Re: Technical Review III
Sound Transit Link Light Rail Tukwila Segment:
Year 2010 Noise and Vibration Compliance Testing Report

This letter presents our technical review of the vibration portion of the compliance report prepared by Michael Minor & Associates (MM&A) on November 17, 2010 and Sound Transit's Supplement to 2010 results, prepared by Ahmad Fazel on September 6, 2011. The MM&A report presents the second of three annual noise and vibration compliance testing results.

Figure 1: Location of BRC measurements at Site V2

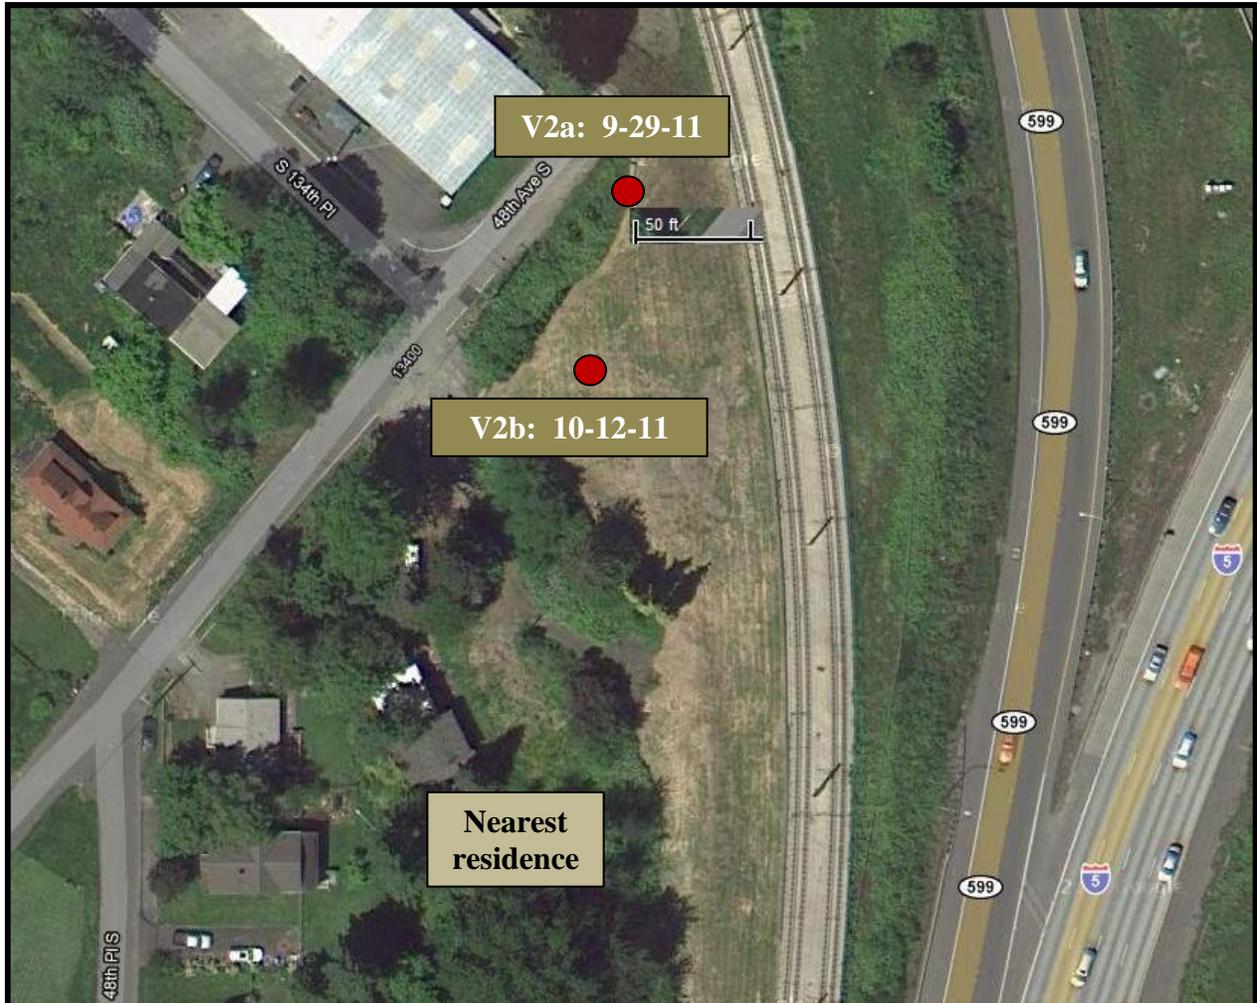
Measurements of vibration were collected at 50 feet from the near rail line at site V2 on 9-29-11 and at approximately 100 feet and 10-12-11. See the location map, Figure 1, on the next page. Average vibration levels at site V2a (50 feet) ranged from 79 to 81 VdB, rms maximum, exceeding the 72 VdB criteria. At V2b, maximum vibration levels ranged from 66 to 68 VdB.

Vibration observed by BRC Acoustics for 5 pass-bys at each location (V2a and V2b) confirms the property line measurements at site V2, reported as ranging from 59 to 66 VdB in MM&A 2010 Compliance Testing Report. The MM&A measurements are estimated to be at a location *more than* 100 feet from the near rail line.

The exact location of the property line is not shown in Figure 4 of Appendix C (page 57), but appears to be very close to site V2b. However, there are portions of the nearest property line which are closer to the rail line, and therefore may be exposed to vibration levels exceeding the FTA 72 VdB vibration limit criteria.
